PAUL MEW ASSOCIATES
TRAFFIC CONSULTANTS 020 8780 0426

CORNER OF FORE STREET AND HIGH ROAD

OBJECTION REBUTTAL

April 2023

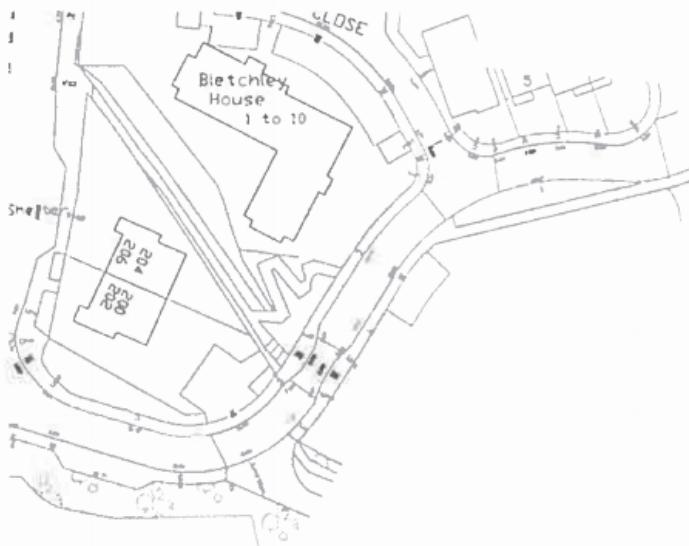
At peak times any available roadside parking spaces are already taken up. It cannot be agreed that the parking spaces given as available in the Transport Survey is correct. The map given within "Figures" towards the end of the Traffic Statement shows unrestricted spaces on the roadside from the Fore Street junction up to Armstrong Close.

There cannot be parking on that side of the road as well as Pretty Corner side due to restricting width of road and thus cars able to pass in both directions. No-one parks on that side, during peak times and indeed very rarely ever. There has to be free-flow ability for traffic turning into Fore Street from Eastcote Road /High Road Eastcote otherwise there will be further traffic hold-ups in the main road. The unrestricted parking spaces in Fore Street are shown right up to Wentworth Drive – a great distance from the nursery. Cannot imagine those dropping off will want to park at such a distance. If spaces are to be found there those dropping off for the existing 2 nurseries, Infants School, Junior School and Grangewood would take those up. There is the width restriction at the bridge in Fore Street just beyond the site so parking at the point is not possible.

2.20 Peak parking surveys have been undertaken which have indicated that all roadside parking opportunities are not already taken up. The surveys are undertaken in line with the Methodology. This includes a 200m walking distance from the site. The width restrictions on the bridge has been considered and is not included within the unrestricted parking count – it has been considered unsuitable.
